SUBJECT: Comanche Peak Nuclear Power Plant, Docket Nos. 50-445 and 50-446,
Compliance with NRC Order Modifying Licenses with Regard to Reliable Spent Fuel
Pool Instrumentation, Response to Request for Additional Information
(Order Number EA-12-051) (TAC NOS. MF0862 AND MF0863)

Attachment Response to NRC RAIs Regarding CPNPP Compliance Report for
Order EA-12-051

NRC RAI No. 2:

Luminant Power Response to RAI No. 2:

FIGURE 2-3b

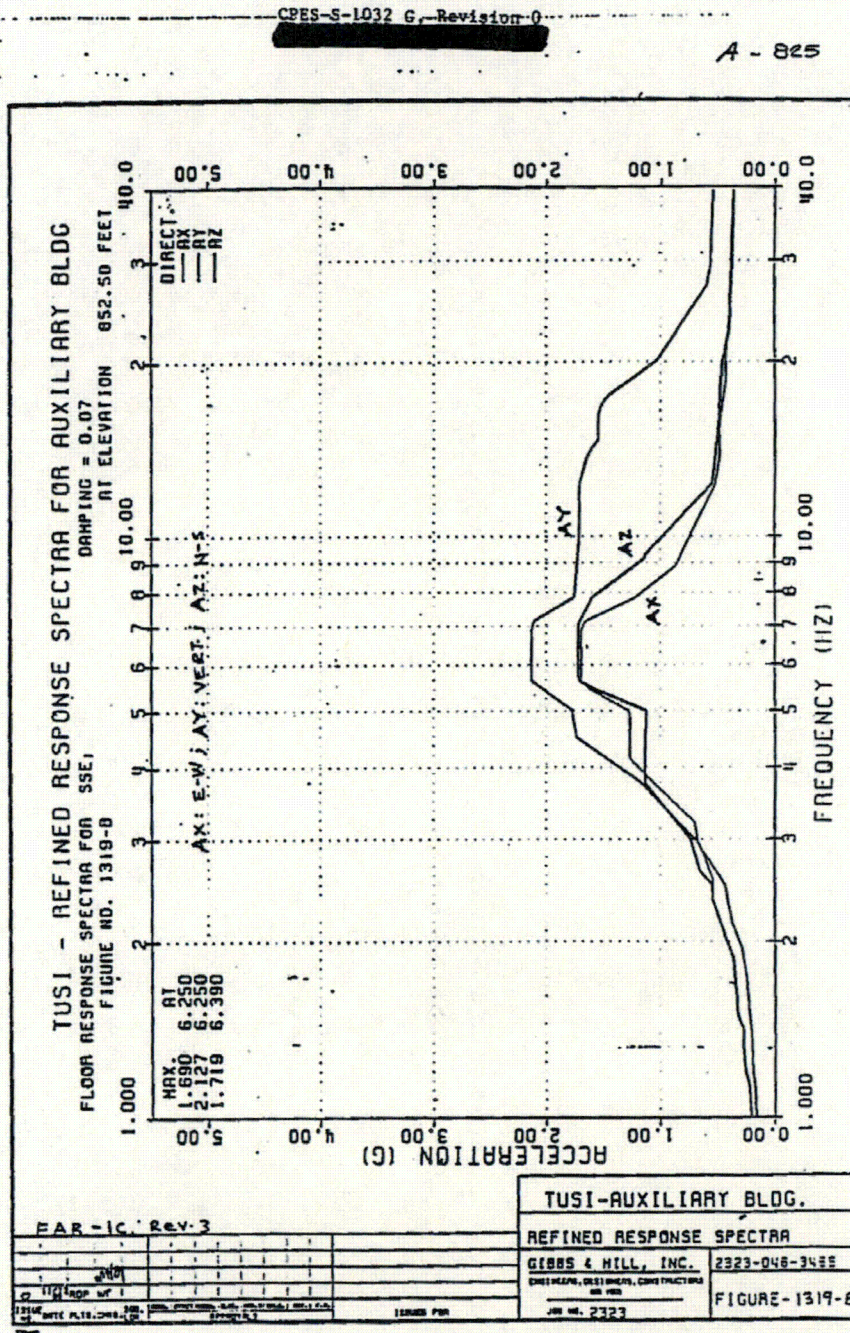
Based on the response, the NRC staff found that the CPNPP Seismic Category II mounting for SFP level instrument does not meet the Order EA-12-051 mounting requirement. Even though the SFP level instrumentation system is non-safety related, the mounting shall be designed considering the maximum seismic ground motion to the design-basis of the SFPI structures to meet the requirements of the order.

The NRC staff requests additional information demonstrating that the SFP level instrument mountings meet the mounting requirements of Order EA-12-051. For each mounting and mounting support, information should be provided including CPNPP documentation with site specific conditions/assumptions, such as the site's design-basis response spectrum for each elevation, pool sizes (hydraulic/sloshing calculation for the probe and mounting bracket), etc. accounted for. Please make available on e-portal for NRC staff review the site-specific seismic calculations (not Westinghouse's generic calculations) for the following:

The level transmitter mounting details are shown in FDA-2013-000008-25-03 on implementation drawing SK-0009-13-000008-25-01 and in Figure 2-6 below. The Seismic Category II qualification of the level transmitter mounting is documented in site calculation CS-CA-0000-5519, revision 1. The analysis of the SSE loads was conservatively based on the use of 1.5 times the peak of the in-structure acceleration response spectra from the 7% curves shown in Figure 2-3b below.

The weight of the level transmitter, its mounting bracket, tributary weight of cables and the conduit coupler was 30 lbs. The anchorage and mounting evaluations performed in CS-CA-0000-5519, revision 1, were conservatively based on a total weight of 40 lbs. The conservative SSE and self-weight loads resulted in a maximum anchor bolt tension of 163 lbs and a maximum shear of 50 lbs. The combined anchor bolt interaction ratio for the level transmitter was then computed to be 0.03 which is significantly less than the acceptance value of 1.0.

The mounting bolts that connect the level transmitter to the mounting bracket were similarly checked for the SSE and self-weight loads. The conservative SSE and self-weight loads resulted in a maximum mounting bolt tension of 140 lbs and a maximum shear of 100 lbs. The combined mounting bolt interaction ratio for the level transmitter was then computed to be 0.15 which is less than the acceptance value of 1.0.
